**ADMINISTRATIVE INFORMATION****FMI No: 25322****FMI Title: LightSpeed 16 DAS Duct Upgrade**

FMI No.: 25322 FMI Title: LightSpeed 16 DAS Duct Upgrade

The purpose of this FMI is to replace the initial version of LightSpeed 16 systems, shipped with a pre-production DAS air plenum, with current production hardware. Please note that the air filters from the old air plenum will not work with the new air plenum.

Figure 1 - DAS Air Plenum: Baffle & Mounting Bolts

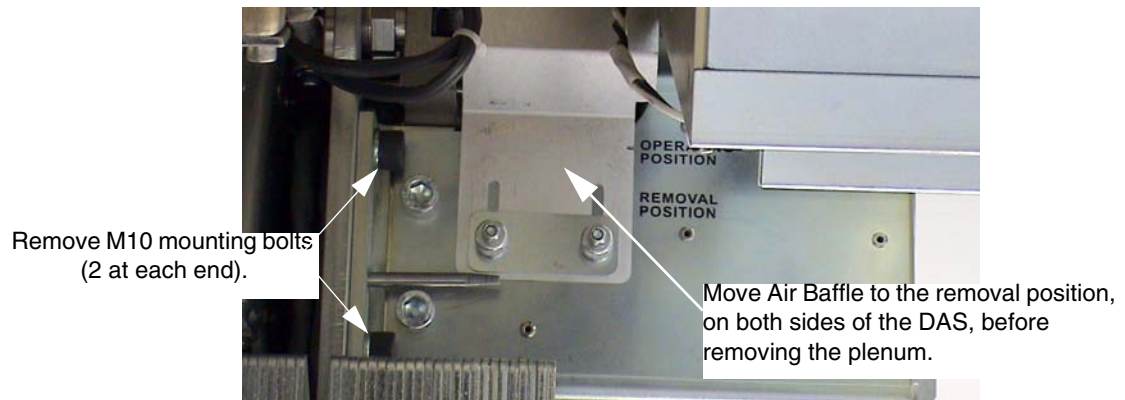
- 1.) Move the table cradle to the home position, and lower the table to its lowest elevation.
- 2.) Remove gantry side cover, and turn OFF all three (3) service switches on the **STC** backplane.
- 3.) Remove the gantry top, side and front covers.
- 4.) Position the DAS at 12 O'clock.
- 5.) Lock the gantry in position, using the rotational lock.
- 6.) Disconnect Fan AC power at Connector J22.
- 7.) Set air baffles on either end of the duct to the "Removal Position" (see [Figure 1](#)):
 - a.) Loosen knurl nuts
 - b.) Slide baffle into position
 - c.) Hand tighten knurl nuts
- 8.) Remove four (4) M10 mounting bolts (2 at each end). See [Figure 1](#).
- 9.) Carefully slide the plenum out, without catching wires or Detector flexes.
- 10.) Set the plenum aside, on a clean surface.

Figure 2 - DAS Air Plenum Installation

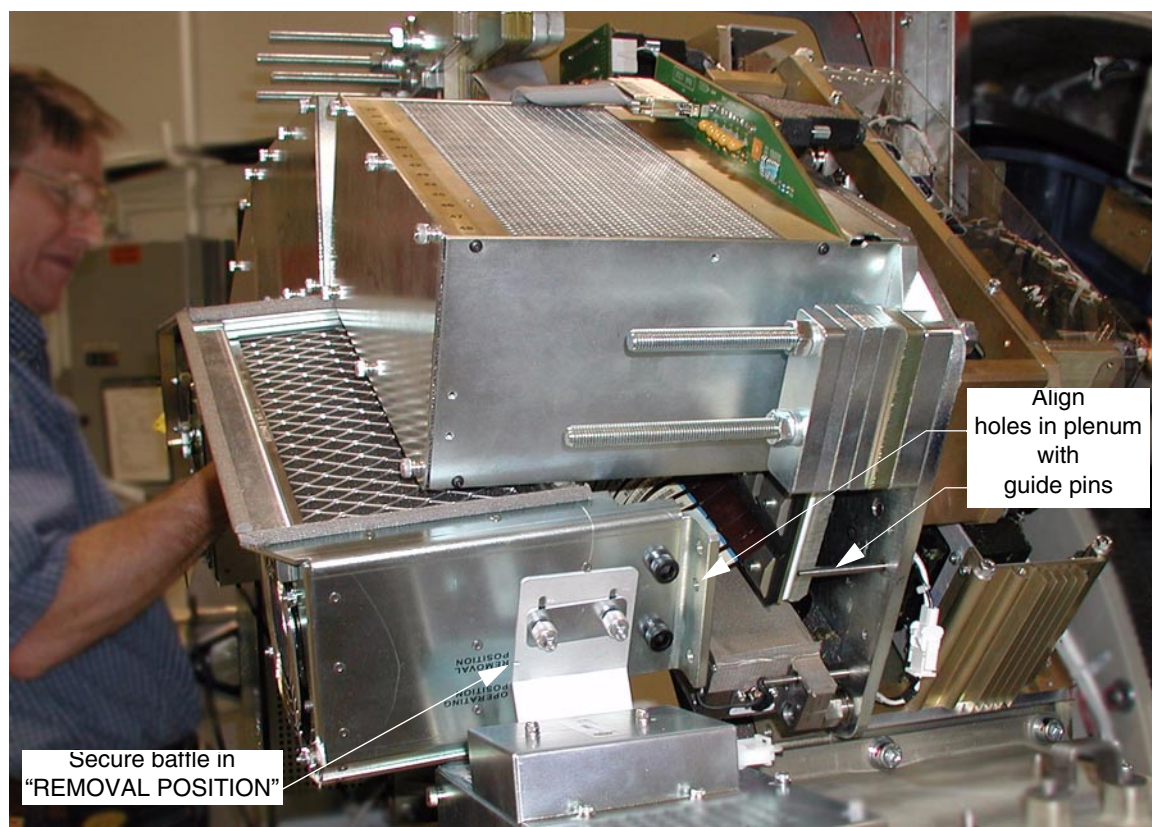
- 1.) Ensure that baffles are secured in "REMOVAL POSITION".
- 2.) Lift plenum into place, and align guide holes with guide pins.
- 3.) Slide plenum onto guide pins.
- 4.) Fasten plenum securely into place, using the four (4) M10 mounting bolts and four lock washers. Torque to 38.4 N-m (28.3 lbs-in).
- 5.) Return baffles to the "OPERATING POSITION".
- 6.) Connect Fan AC power at Connector J22.
